PLANNING AND ENVIRONMENT ACT 1987
WHITEHORSE PLANNING SCHEME

**Proposed Mixed-Use Development
160 Whitehorse Road, Blackburn
Response to Request for Information**

Ratio Consultants has reviewed the correspondence received from the City of Whitehorse, dated 3 May 2019, in response to the application for a mixed-use development on the site located at 160 Whitehorse Road, Blackburn.

Figure 1: Grease Intercept Trap (GIT)

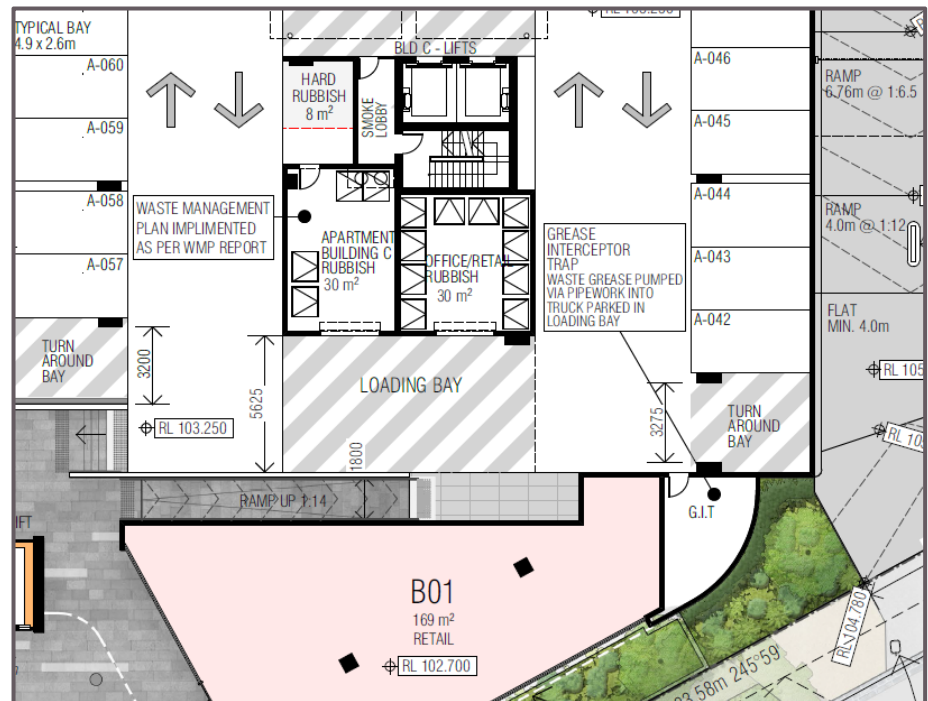
6. b. Details of how access to waste collection area/grease traps will be achieved by waste collection vehicles (i.e. via the intercom). When propped, the grease removal truck, must not block access to or from car spaces.

The Grease Intercept Trap (GIT) is located near the loading bay within Basement 1, as illustrated in Figure 1 below.

Grease collection vehicles will be able to prop within the loading bay when collecting grease and accordingly will not block access to or from any car parking spaces.

The grease collection vehicle will be able to access the site via a swipe card or remote-control unit.

Figure 3: Changes to Internal Intersection

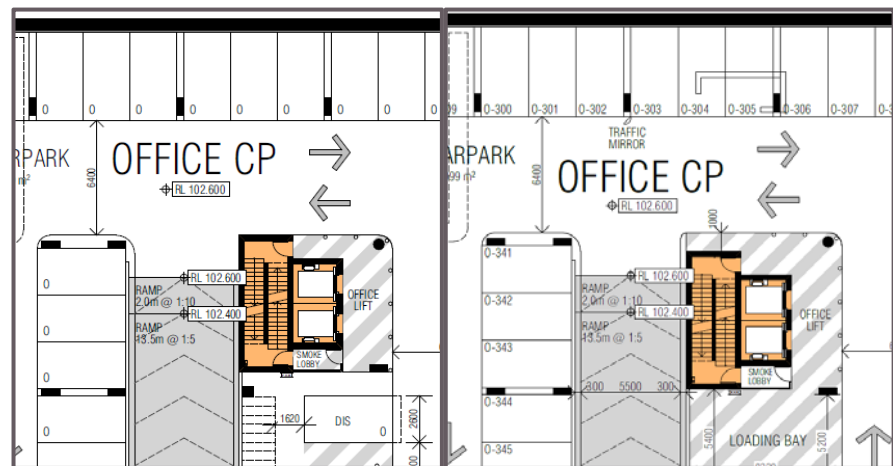
H.c. Officer car park at Basement Level 1 provides poor visibility between vehicles emerging from the down ramp and on-coming traffic due to the wall provided to the stair core

The stair core adjacent to office car park ramp from Basement Level 1 to Basement Level 2 has been shifted back from the aisle by 1.0 metre. The revised position of the stair core will enable opposing vehicles to observe each other and adequately manage a conflict in the event that two opposing vehicles meet at this internal intersection.

Furthermore, it is proposed to provide a convex mirror at this location to further improve sightlines between opposing vehicles.

The changes to this internal intersection are highlighted in Figure 3.

Appendix B Office Loading Bay Swept Paths

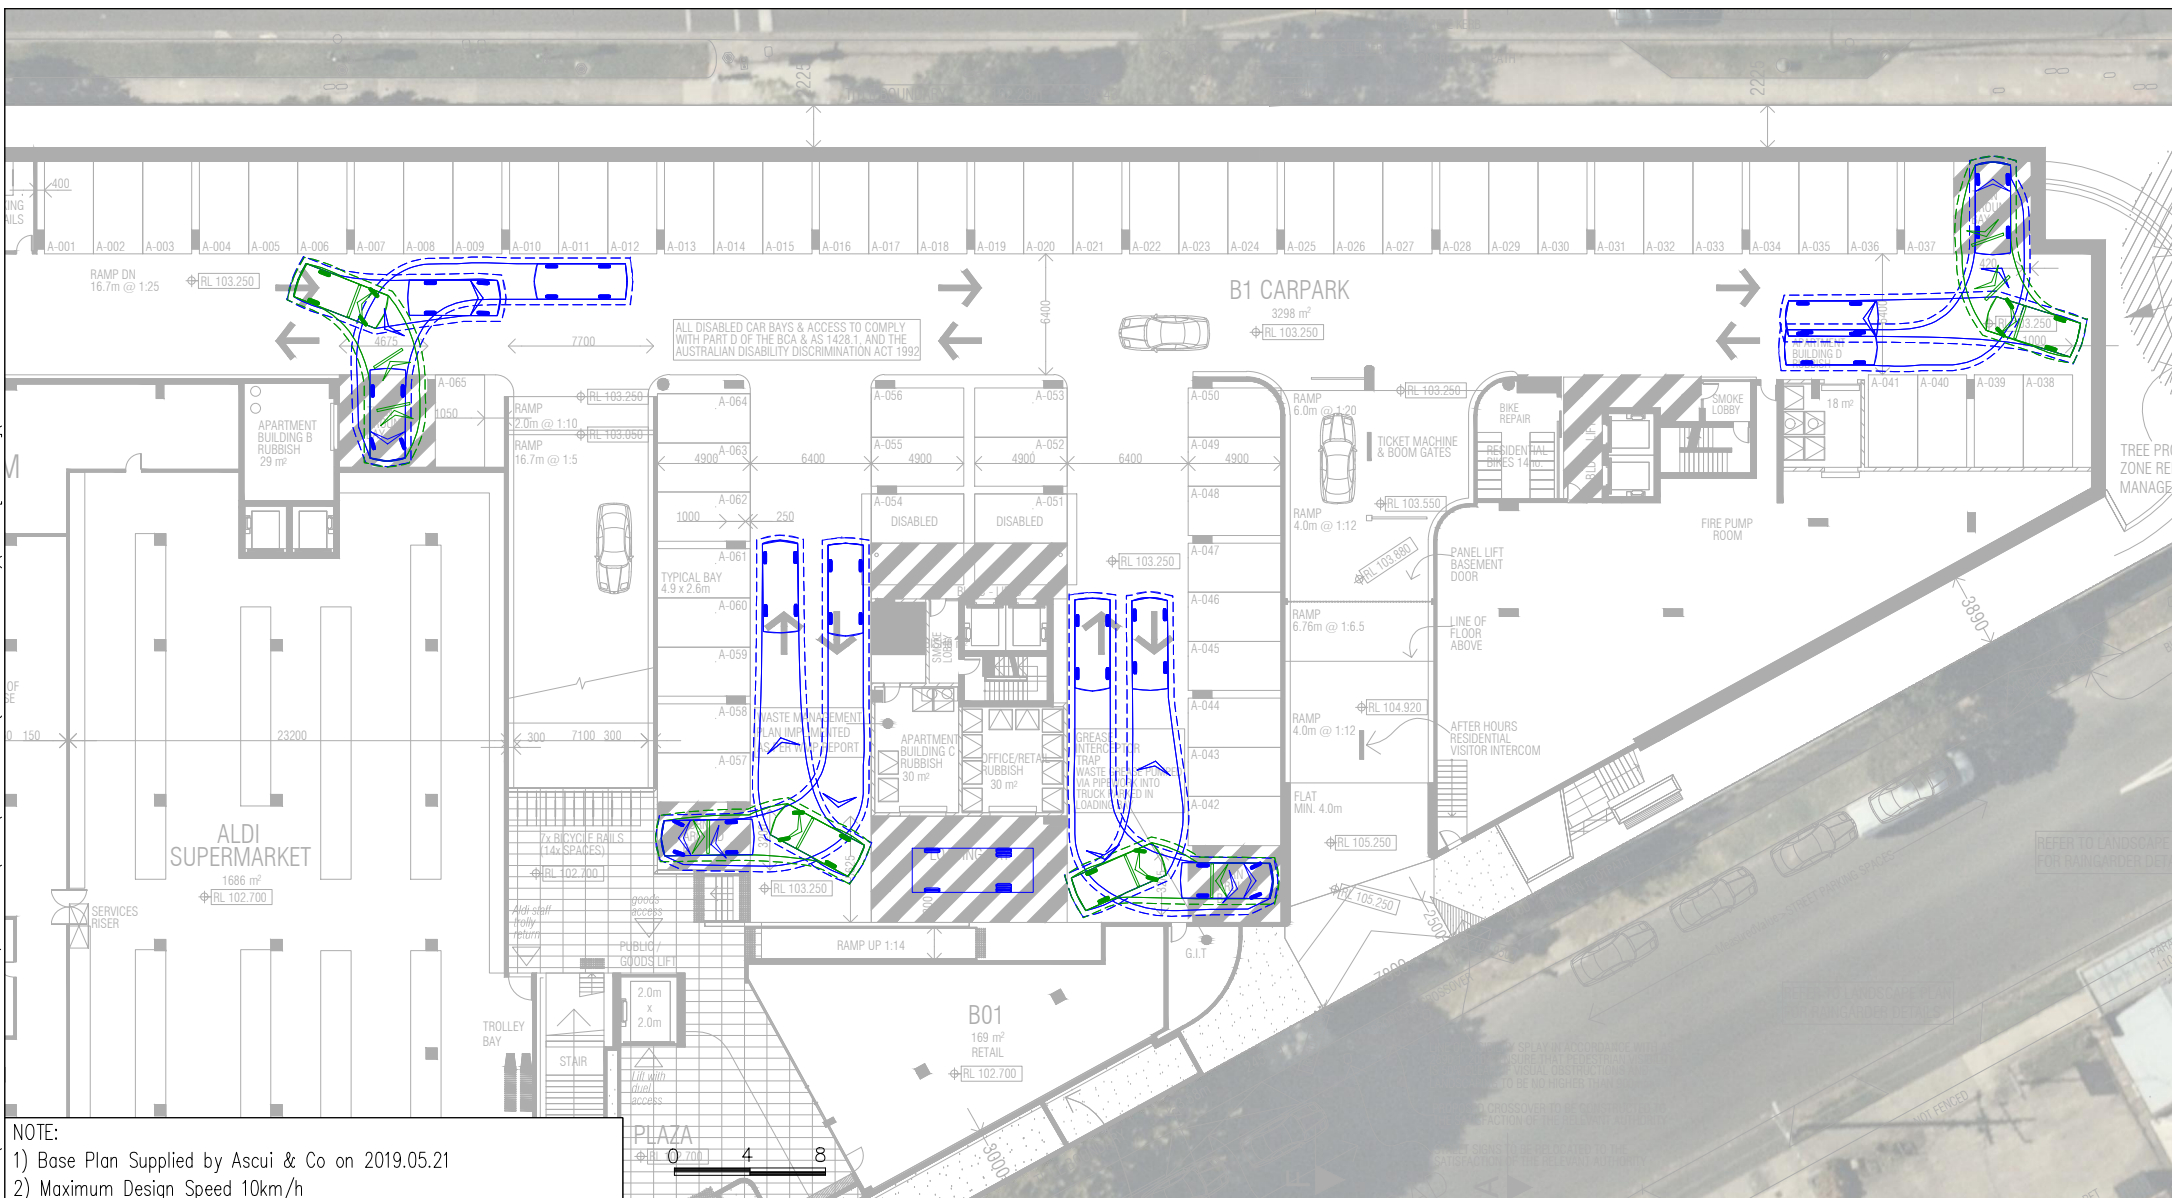
B. The provision of one loading bay serving the large office tenancy and 13 commercial tenancies and supporting six waste collections per week is insufficient, and likely to result in either waste or delivery vehicles propping in the aisles and blocking access to car spaces, when two or more such vehicles attend the site at one time.

To facilitate these deliveries, it is proposed to provide a dedicated loading bay within the office car park. The loading bay is able to accommodate a 6.4 metre long SRV which would be sufficient to cater for the vast majority of deliveries associated with the office tenancies.

The swept path assessment attached in Appendix B demonstrates the ability for the SRV to access the office loading bay in a suitable manner.

Appendix D Swept Path Assessment – Circulation around Intercom & Ticket Machine

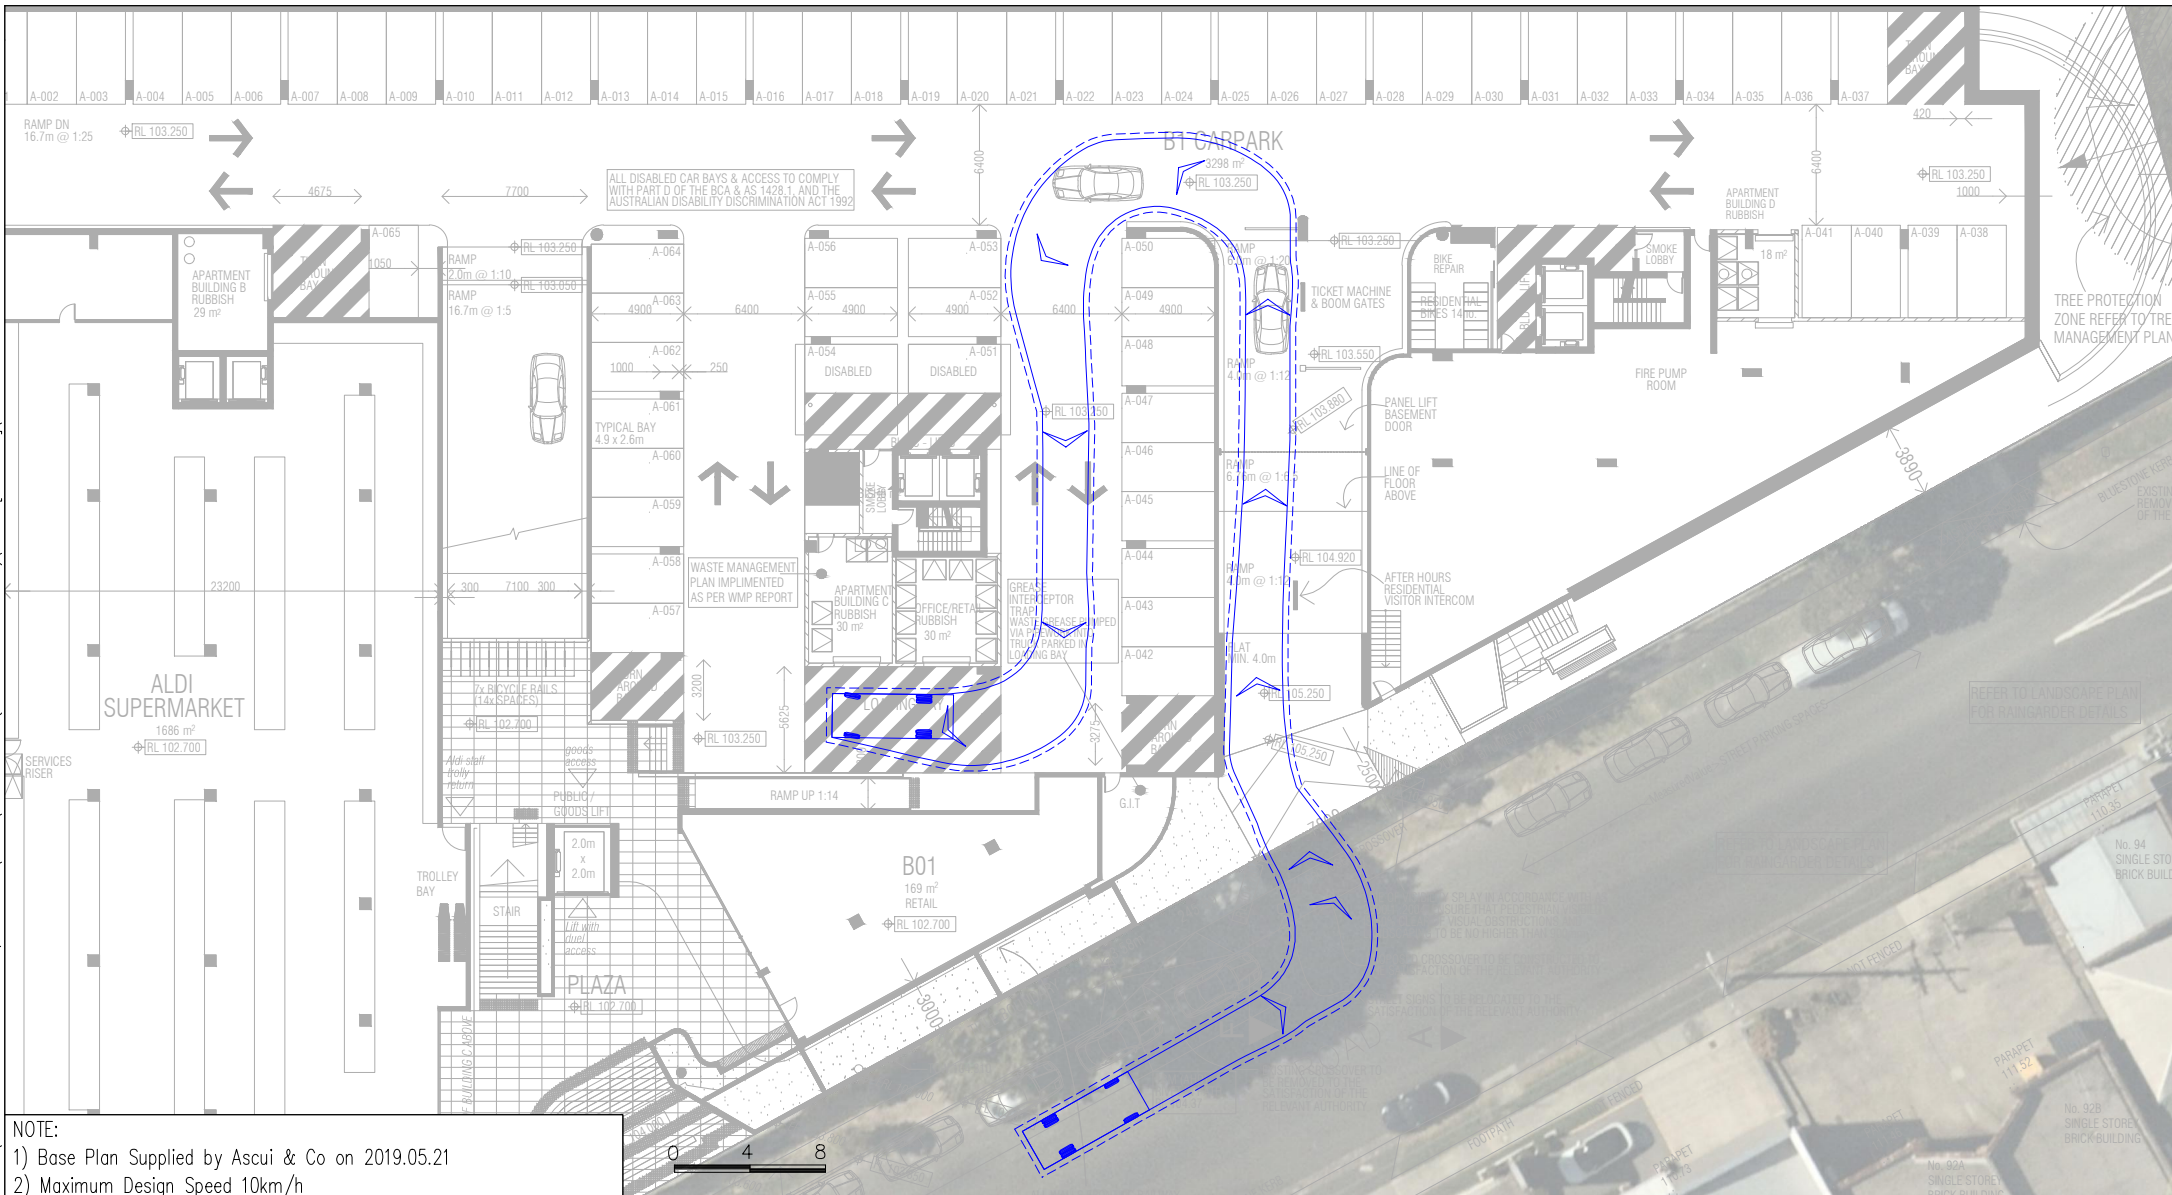
H.f. The position of the ticket machine and intercom require precision driving for waste and delivery vehicles to manoeuvre around them.

The swept path assessment undertaken within Appendix B of the Traffic Impact Assessment Report (TIAR) demonstrates that the largest vehicle anticipated to access the basement car park (a 6.4 metre long Small Rigid Vehicle as defined by AS2890.2) is able to manoeuvre around the ticket machine and intercom (upon entry and exit to the site) in a suitable manner, with 300mm clearance to these obstructions as required by the Australian Standard. The swept paths of a 6.4 metre long Small Rigid Vehicle have been updated on the latest architectural plans and attached at Appendix D.

Accordingly, it is considered that the position of the ticket machine and intercom is satisfactory.

Proposed Mixed-Use Development
160 Whitehorse Road, Blackburn
WASTE COLLECTION TURNAROUND BAY

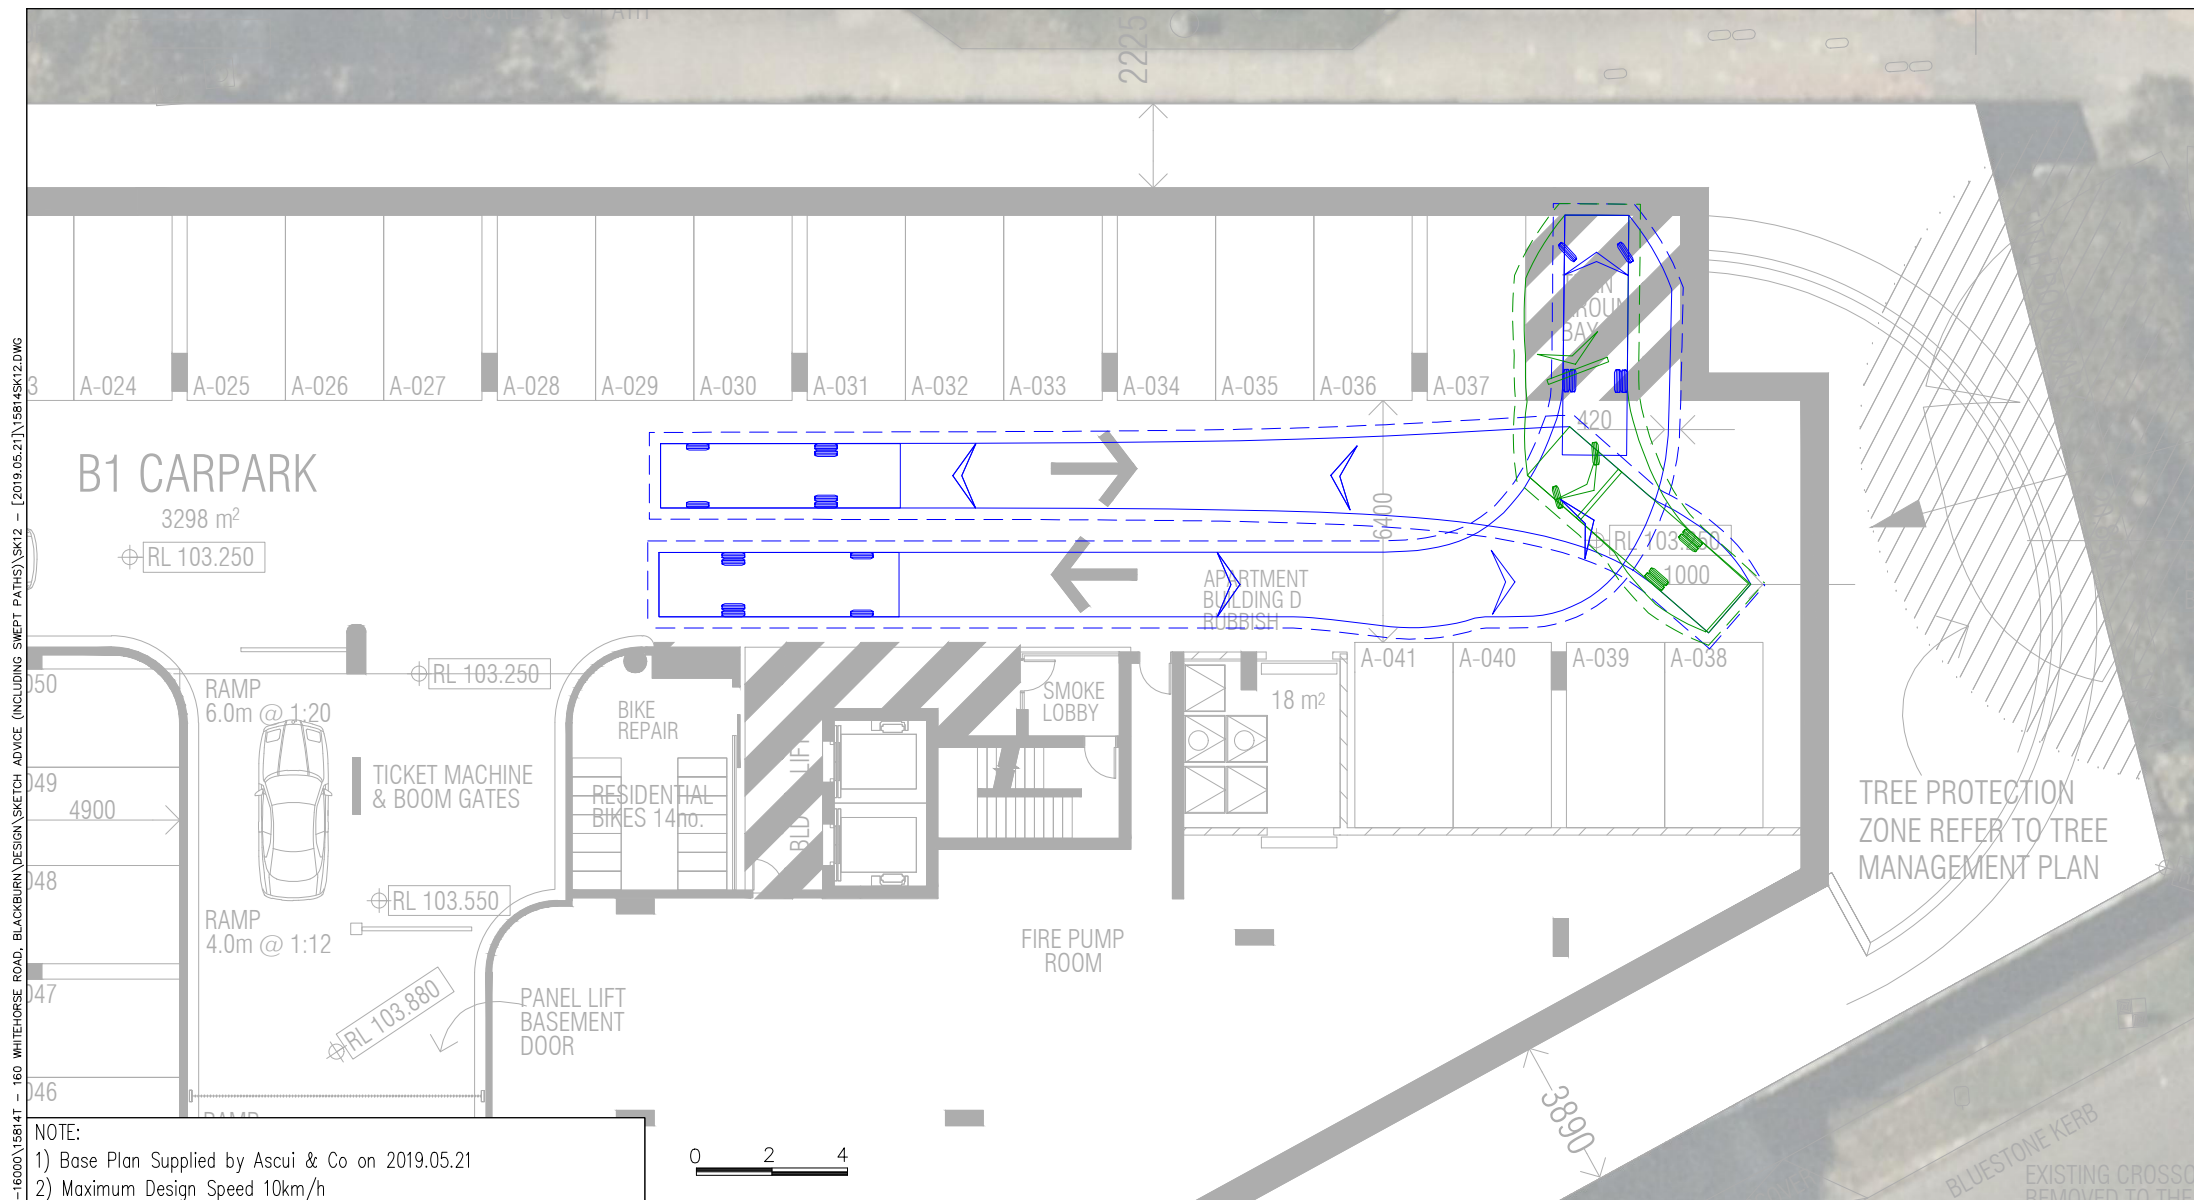
H.g. Concern that the waste truck is required to reverse within the basement car park.

The inclusion of a turnaround bays within Basement 1 has removed the need for the waste collection vehicle to reverse any significant distance within the car park.

A swept path assessment is attached at Appendix E of this letter which demonstrates the ability for the waste collection vehicle to manoeuvre within these turnaround areas and depart the site in a forward direction.
